# RE-ENVISIONING NORTHGATE MALL

Major Phased Development | DRB Recommendation - 03  
SDCI # 3032055-EG (MPD # 3031301)  
03 June, 2019 - Meeting Date  
Planner: Brandon Cummings

## BUILDING H1 - HOTEL

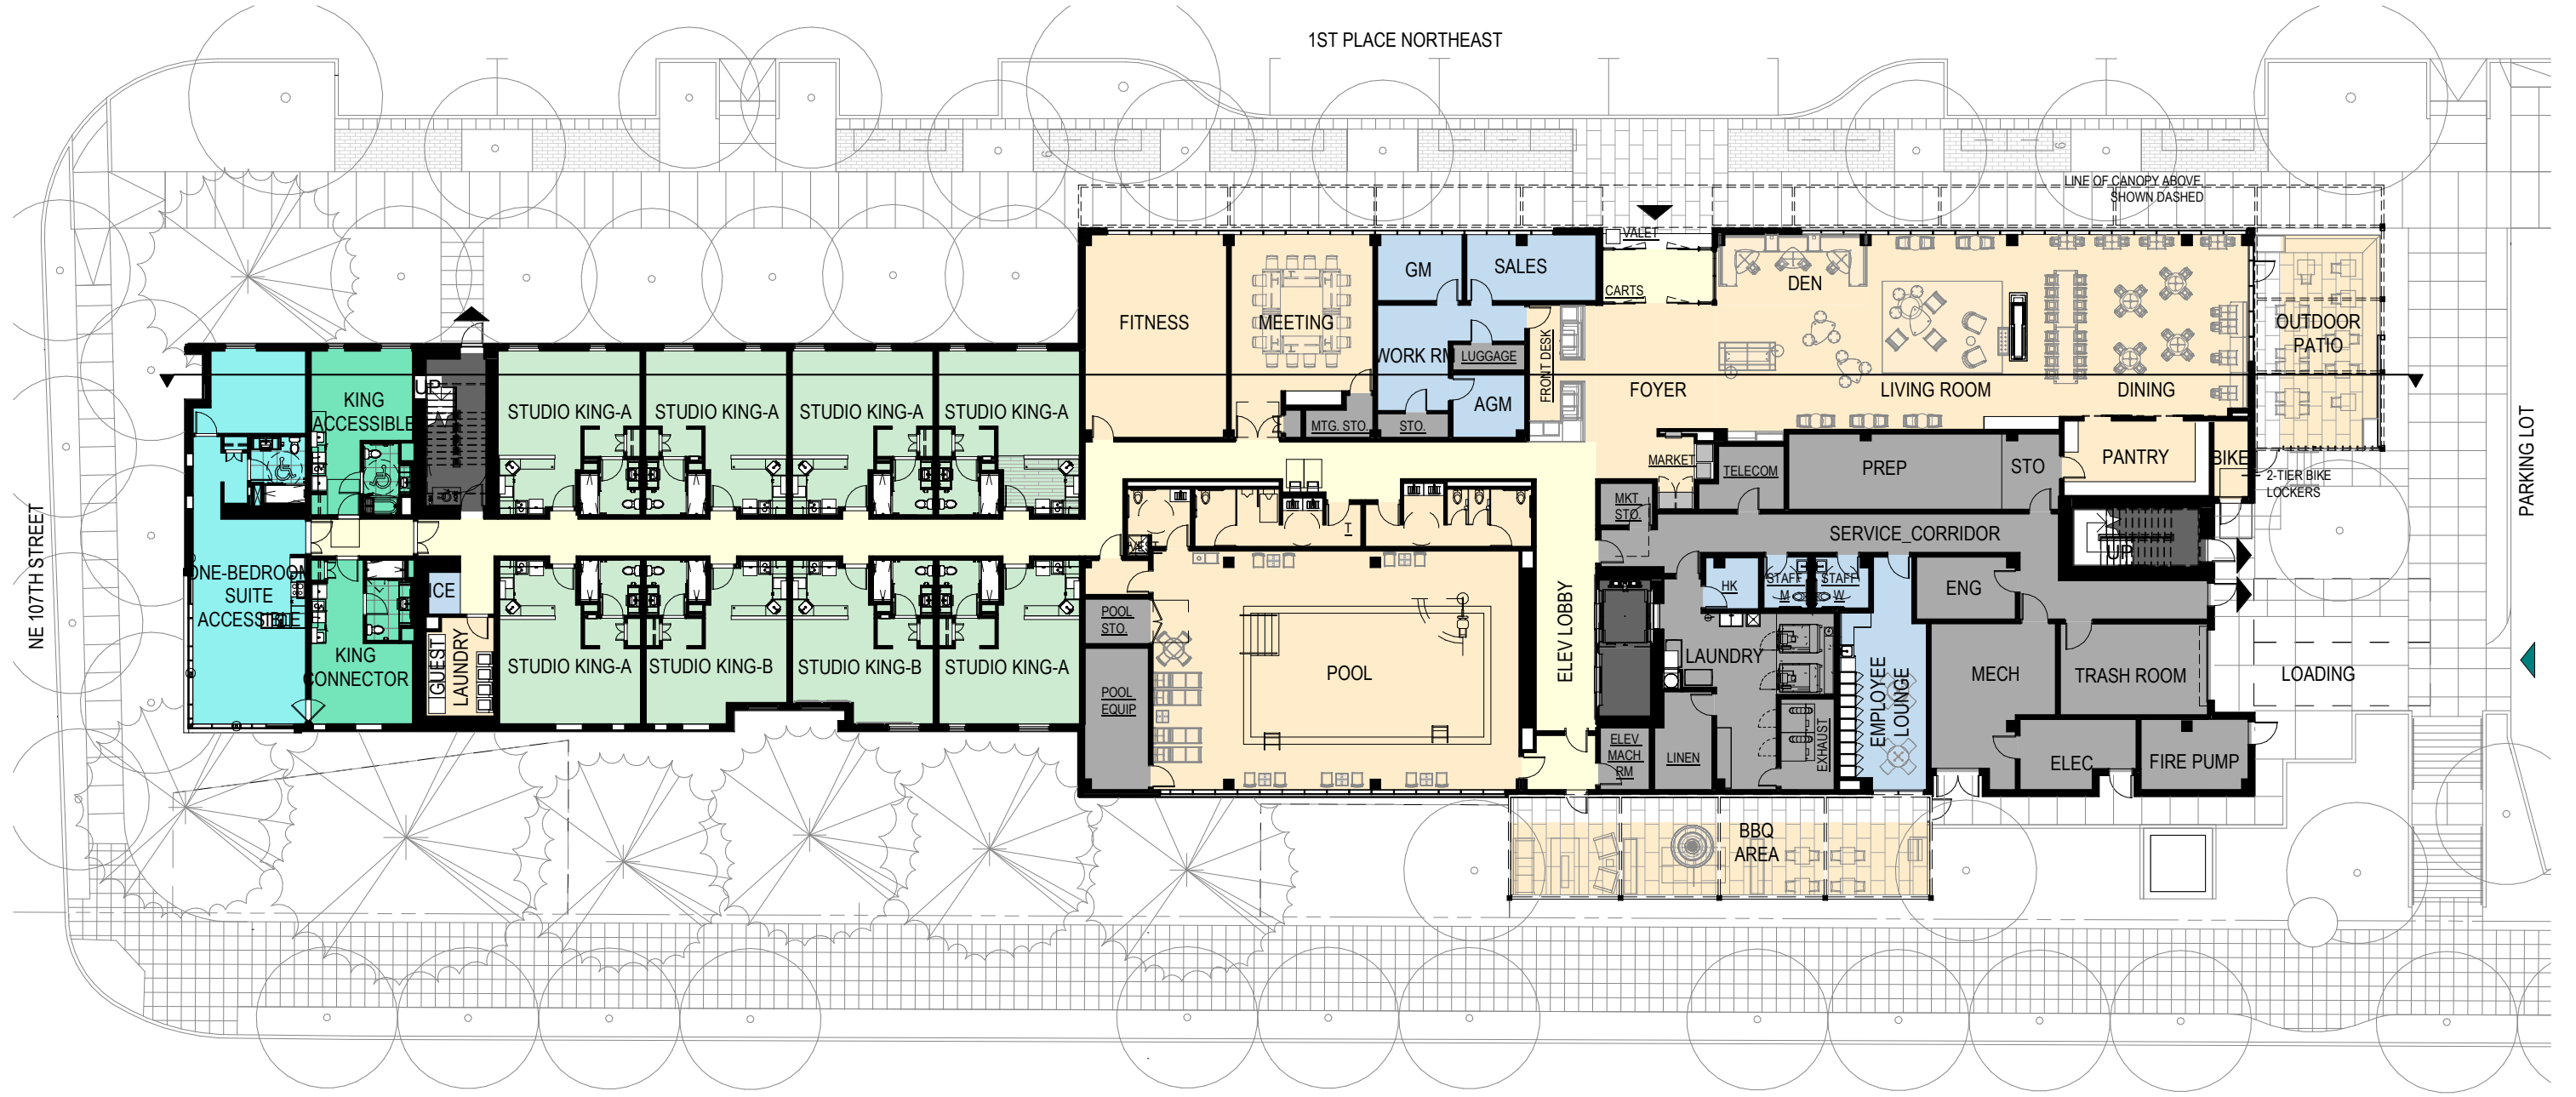
Comment: Massing and Facade Composition: The Board supported the project's design response to the guidance provided at the Early Design Guidance (EDG) phase concerning the design of the H1 Hotel Building. As detailed below, the Board was in support of breaking down the massing, and how the ground plane addressed the surrounding streets. However, the Board was concerned with the facade composition and proposed application of the material palette. (DC2-A-2. Reducing Perceived Mass, DC2-B-1. Facade Composition)

The Board was concerned with the massing modulation as proposed, and recommended breaking the building into two distinct masses with a simpler form and facade composition. The Board also indicated support for an architectural expression that is more horizontal in nature. (CS2-A-2. Architectural Presence, PL3-V-iii. Facade Articulation, DC2-B-1. Facade Composition)

The Board recommended simplifying the application of the material palette, facade articulation, and arrangement of fenestration to create facades that are attractive and well-proportioned. The Board also suggested utilizing appropriate materials at specific locations to drive the overall design language for the structure. (PL3-V-iii. Facade Articulation, DC4-A-1. Exterior Finish Materials)

*Response: The massing has been simplified by reducing the building recesses to one on each facade. This breaks the building into two distinct masses, instead of several. The recess also creates a natural place for the wood-look metal as a material feature.*

*The dark mass in large metal panels retains the same expression as was shown in the previous meeting - with the interactive play of fill and void that suggest a "moving" facade.*

*The light mass in fiber concrete system has been streamlined by aligning the fenestrations and eliminating the stacked window recesses to emphasize horizontality. The same architectural language and materiality is used from the top of the building to the ground plane to create a clear and modern expression.*

*Stone veneer system is used at the prominent building base to provide a unique character and to ground the structure.*

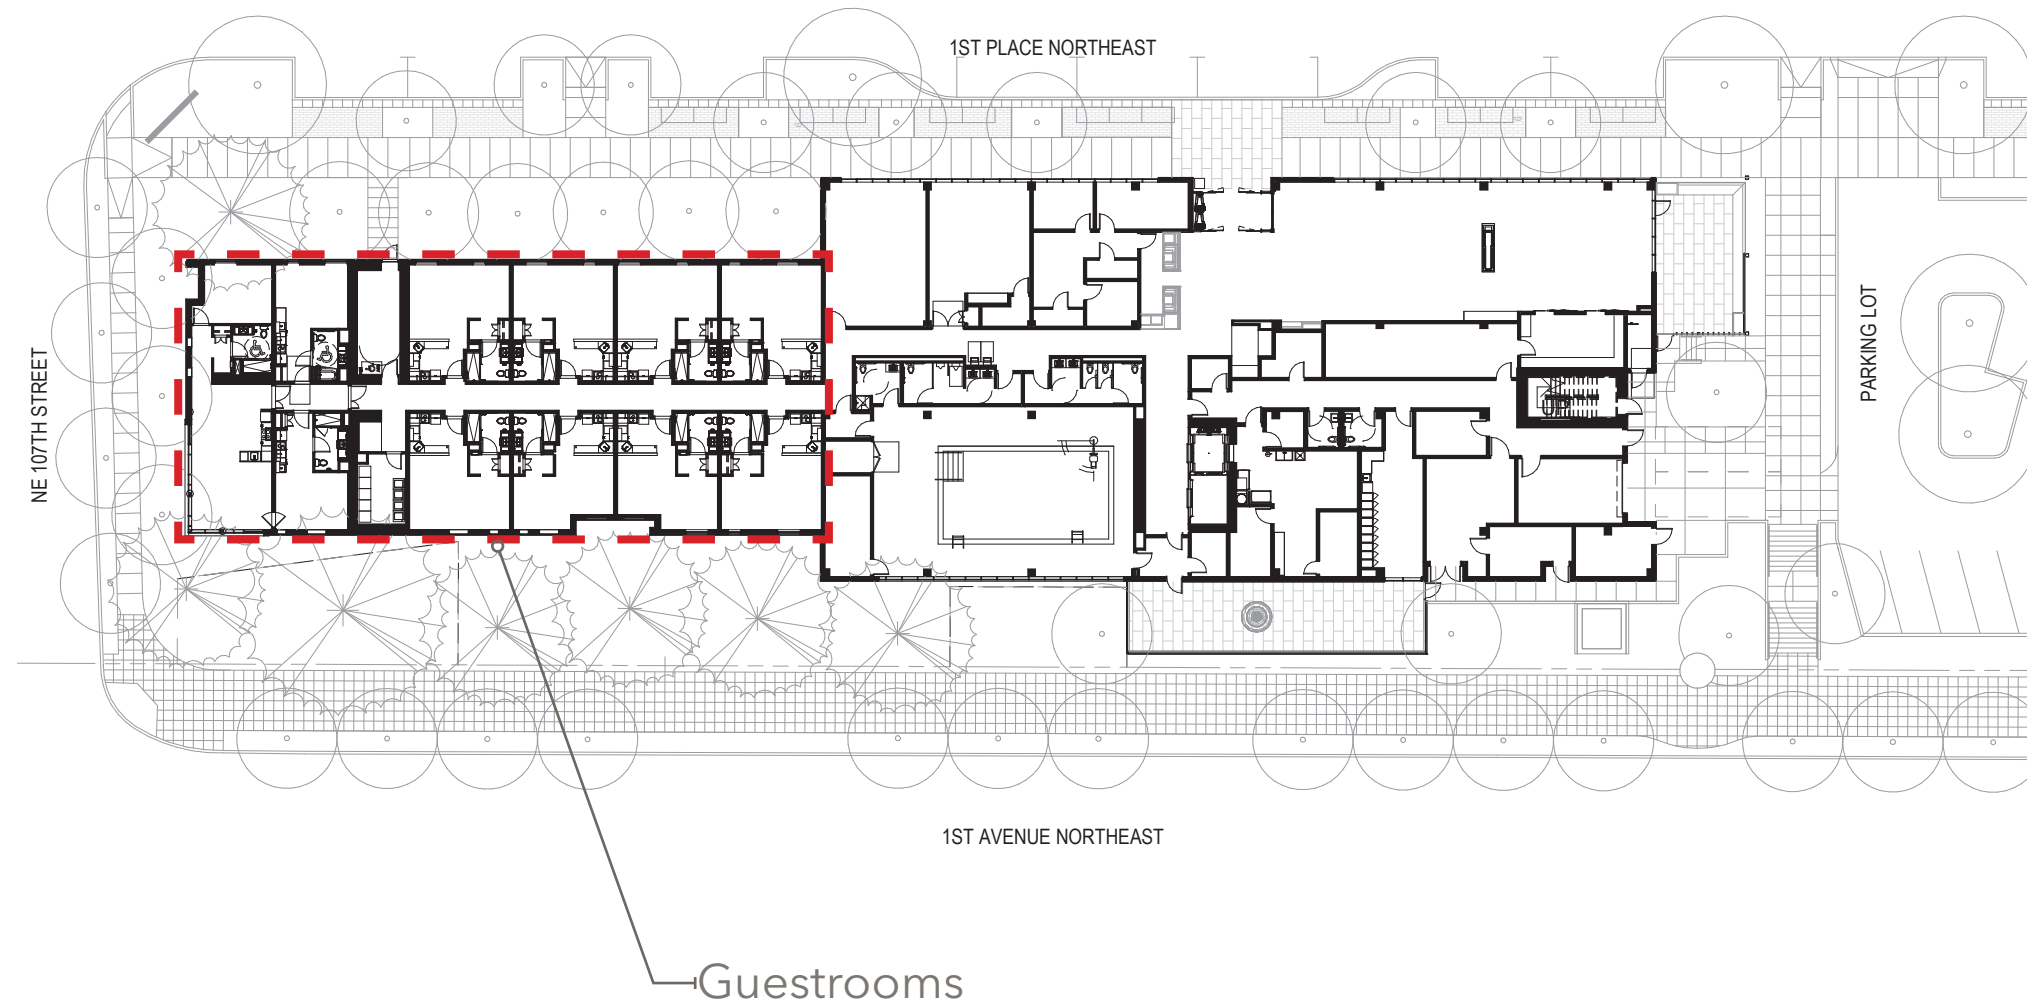
- East Facade = 53.4%
- West Facade = 41%
- North Facade = 45%

*Departure Rationale:*

*The glazing percentage at the east and north facades is below 60% due to the guestrooms located at the north end of the property. Being at grade level, the rooms do not want to have excessive amounts of glazing due to privacy concerns. The rooms have a standard window size which limits the glazing quantity.*

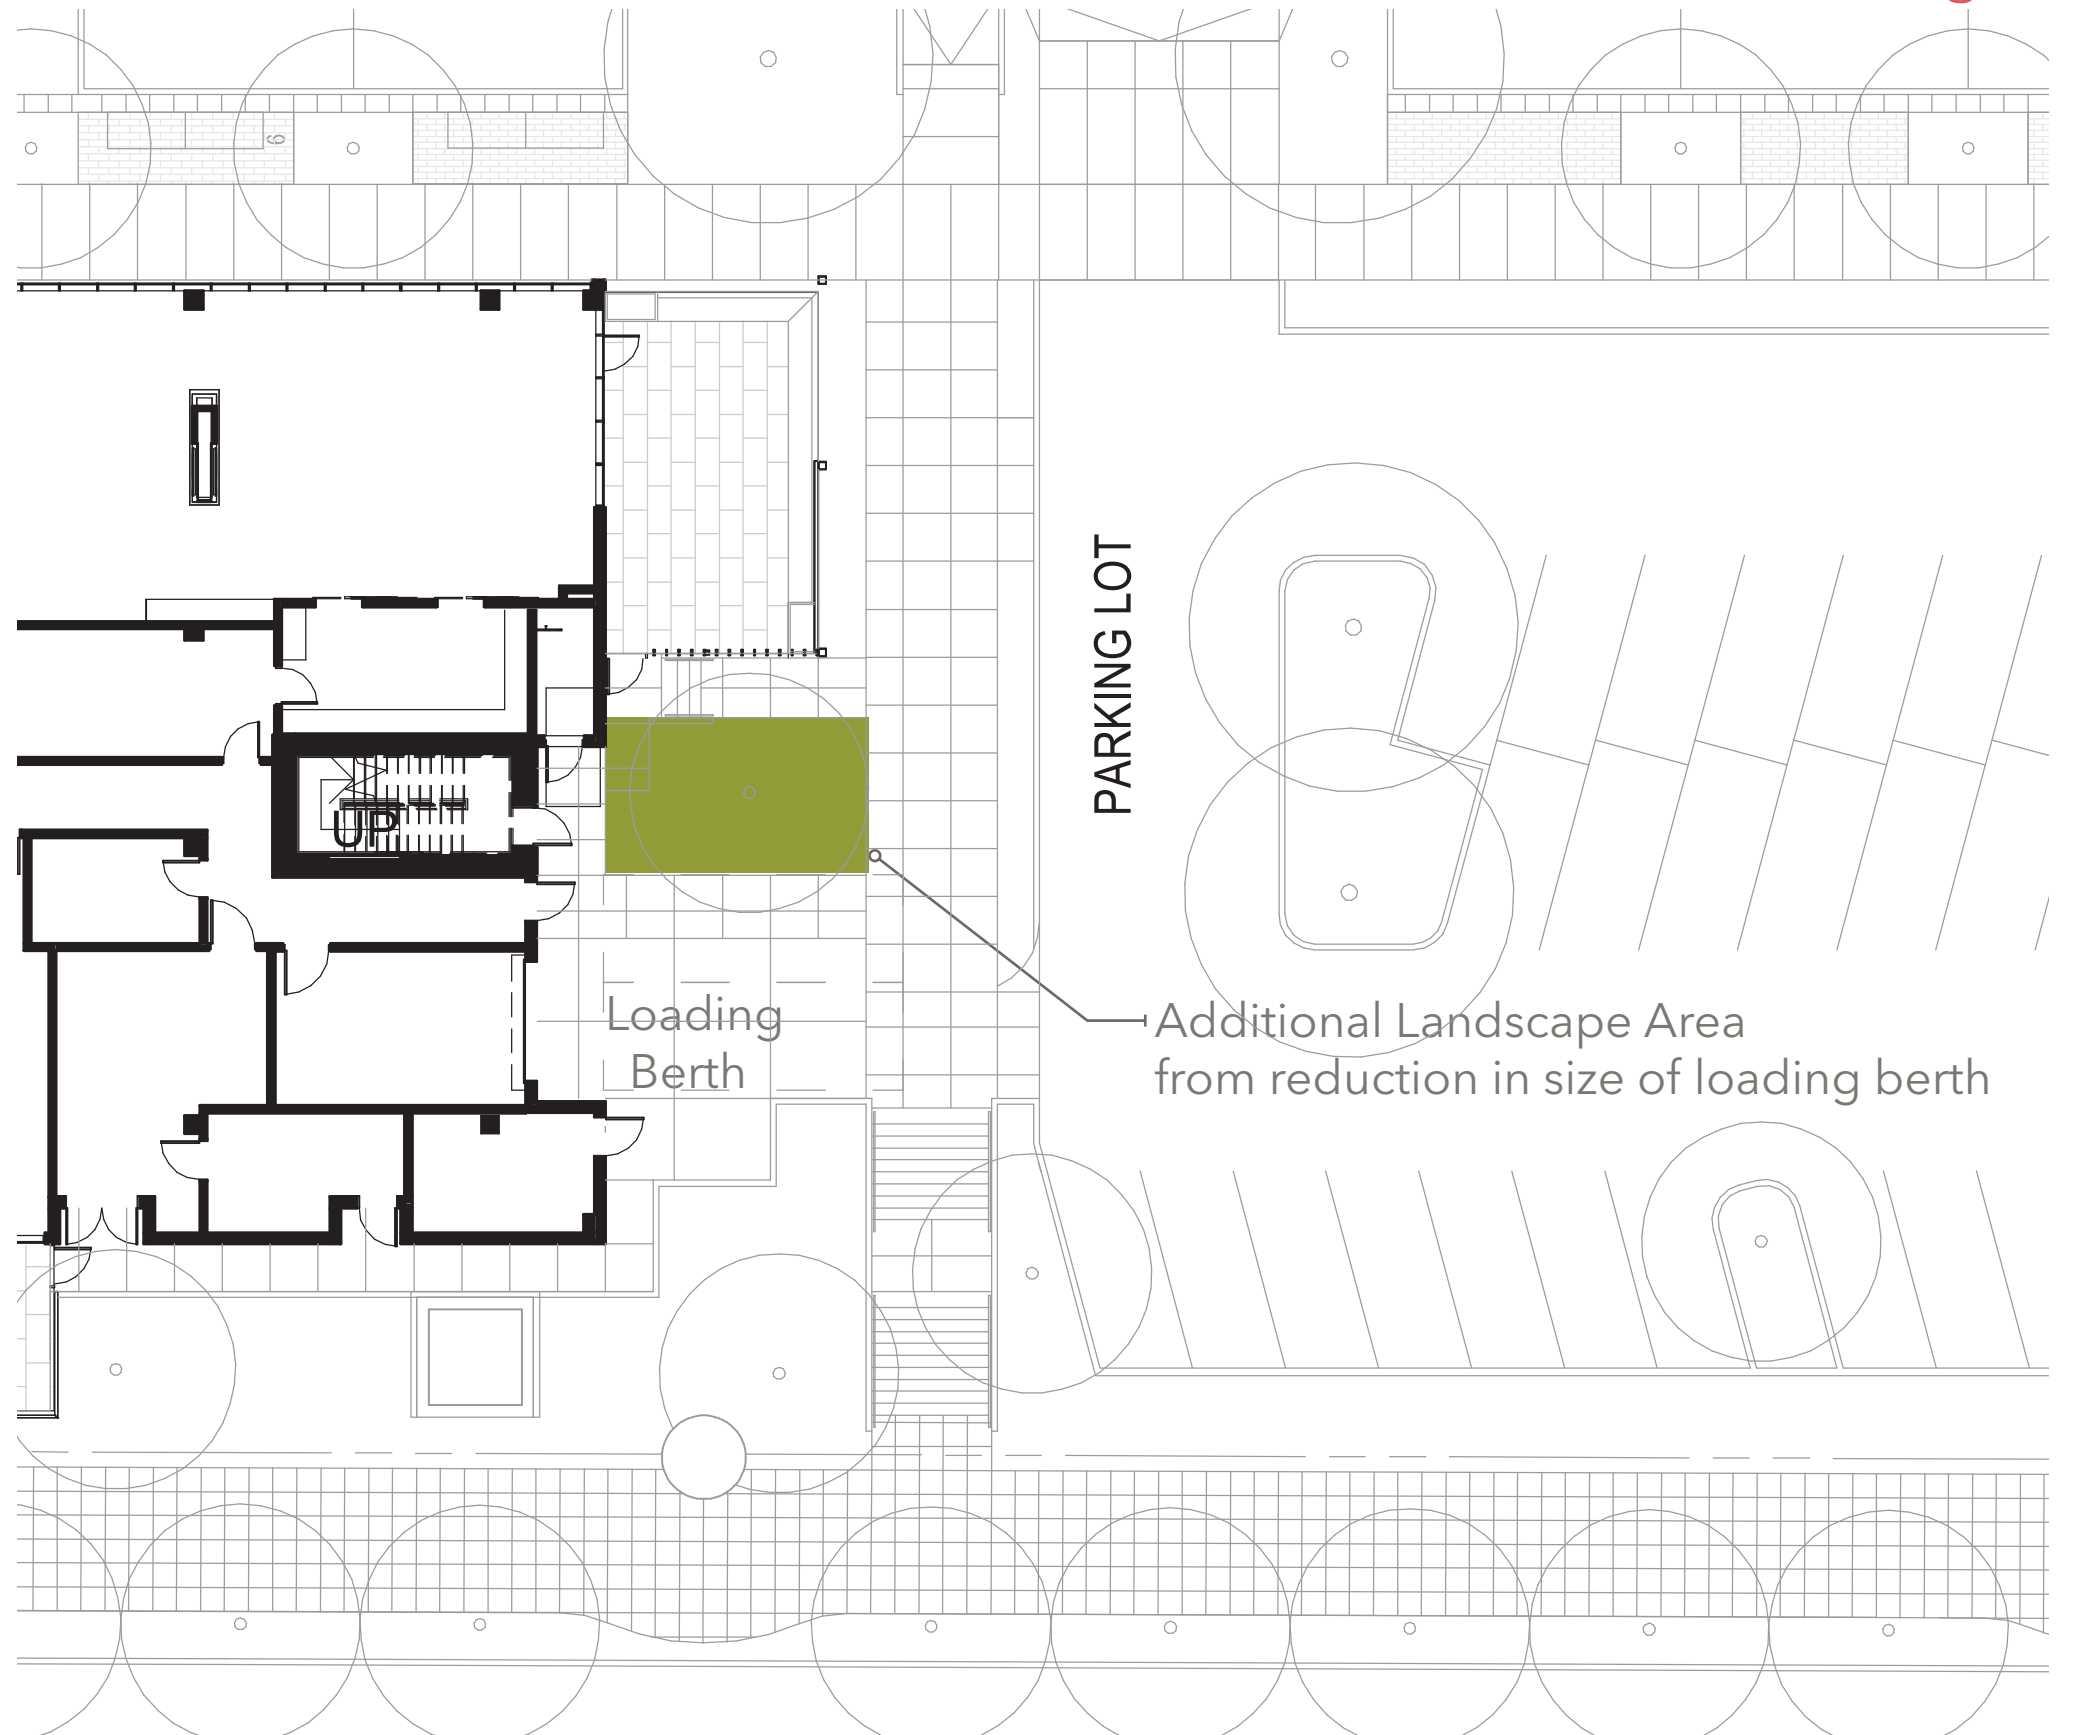
*Departure Request:*

*Two loading berths (9 ft x 25 ft) are proposed for the building. The team feels that the space reduction will be better used for landscaping.*

*Landscaping will provide a better pedestrian experience for people coming from 1st Avenue Northeast via the stairway. It also acts as a screening element, obscuring views to the back-of-house entrances from the public outdoor patio area.*

# BUILDING H1 - AMENITY TERRACE LANDSCAPE PLAN

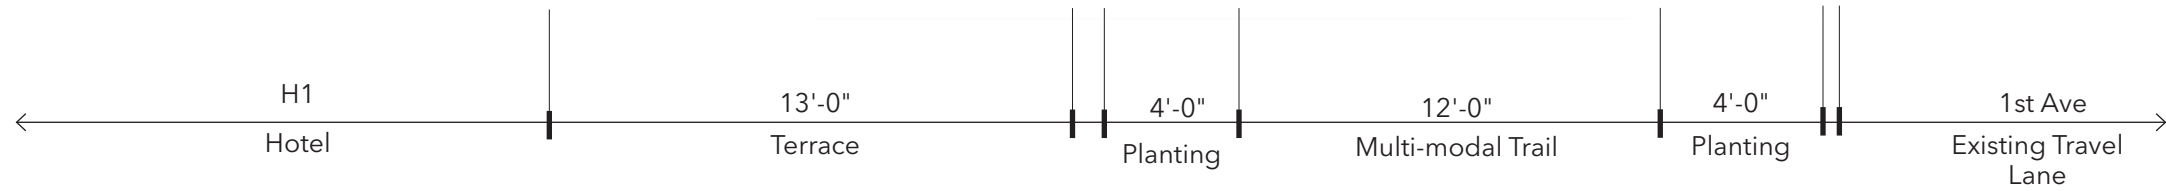
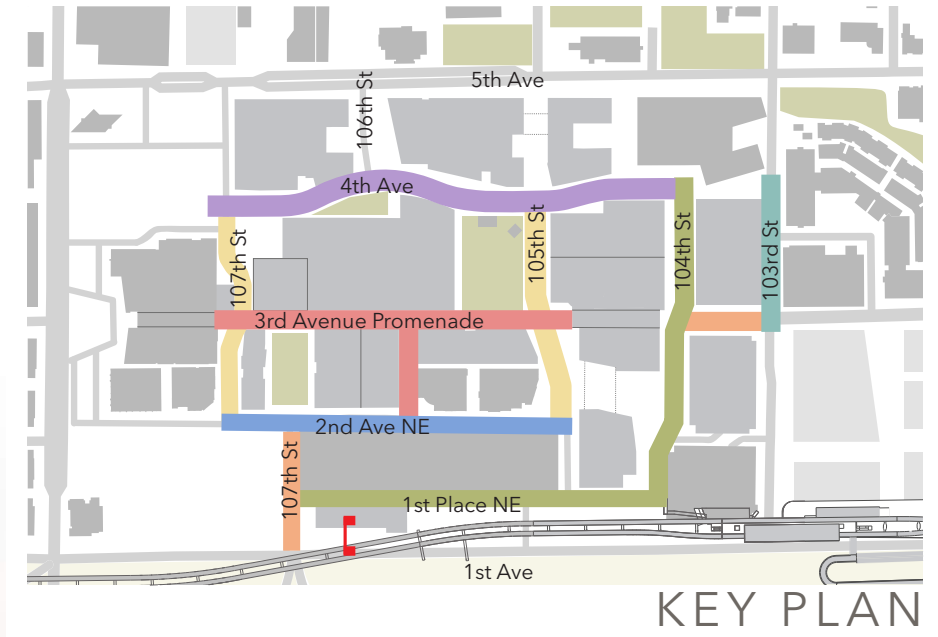
Board Comment: Outdoor Amenity Areas: The Board supported locating the outdoor amenity areas along 1st Avenue Northeast but was concerned over the proposed configuration. The Board recommended combining the bbq area with the shuffleboard area to improve the functionality of the space and take advantage of the proposed building circulation.

*Response: The terraces were consolidated into one space, with similar program as before, about 13' x 58'. From the main interior access point, a view to a lounge with fire pit give place for outdoor table tennis or foosball play, then to a small dining patio with BBQ counter and seating.*

*New survey information came in April, and grade change between the existing 1st place and 1st Avenue NE is more pronounced than expected. Grade change between the trail and the terrace is expected to be around 8' height. We will employ all techniques available to reduce its perceived height.*
